**Subject: 3rd Submittal DS and Plans for 24-0046**

This letter and accompanying revised Technical Drainage Study and Civil Improvement Plan Set are provided as the 3rd Submittal DS and Plans for 24-0046 concerning NV Energy's proposed Northwest Substation Expansion. Listed below are the City of Las Vegas' 11 comments received on 2/24/2025 from Tyler Key, with NV Energy's response following each comment.

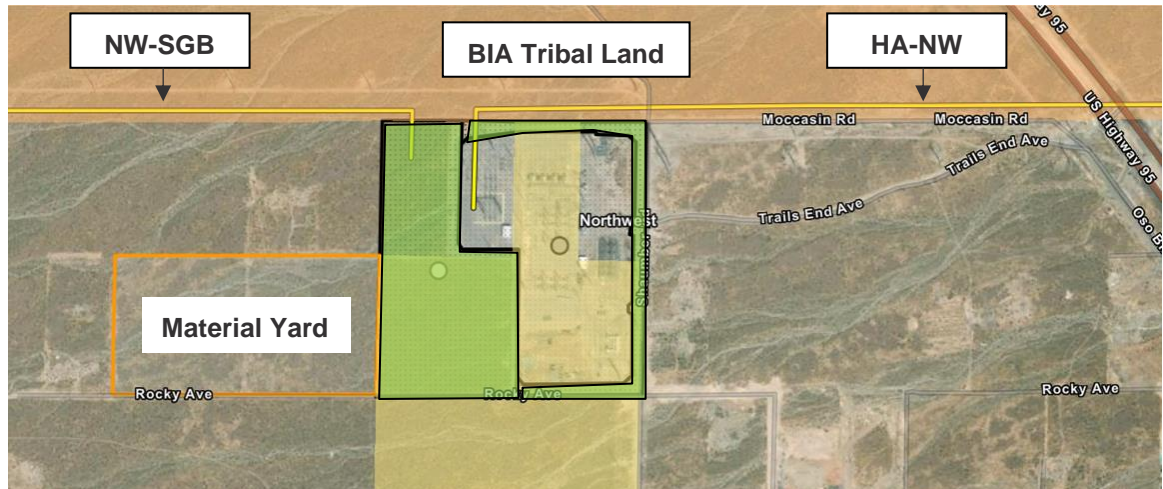
2. The site is also adjacent to the jurisdiction of Clark County to the north. The engineer must coordinate with Clark County Public Works Department (CCPW) and incorporate any concerns for boundary conditions along Moccasin Road. CCPW concurrence is required prior to final approval of the study.

On 3/3/2025, NV Energy contacted Mr. Antonio Papazian with CCPW to review the comment above. In NV Energy's 3/3/2025 email to Mr. Papazian, we noted that the jurisdiction to the north

of the proposed Northwest Substation expansion is Bureau of Indian Affairs (BIA) land for the Las Vegas Paiute Tribe's Snow Mountain Reservation. In the screenshot below, the Northwest Substation expansion area is shown in light green. Moccasin Road doesn't appear to extend farther west than the northeast corner of the existing Northwest Substation footprint.

On 3/13/2025, Mr. Papazian replied and asked if any improvements are proposed north of the centerline of Moccasin Road. NV Energy replied that no improvements are planned north of Moccasin Road. The proposed Northwest to Sagebrush 525 kV transmission line (**NW-SGB**) extending west from the Northwest Substation Expansion area will be situated on BIA-administered land. NV Energy's proposed Harry Allen to Northwest 525 kV transmission line (**HA-NW**) originating at the existing Harry Allen Substation and terminating at the existing Northwest Substation will be permitted separately in 2026/2027. This proposed transmission line will be situated north of Moccasin Road's centerline but is not part of the current Technical Drainage Study for the Northwest Substation Expansion.
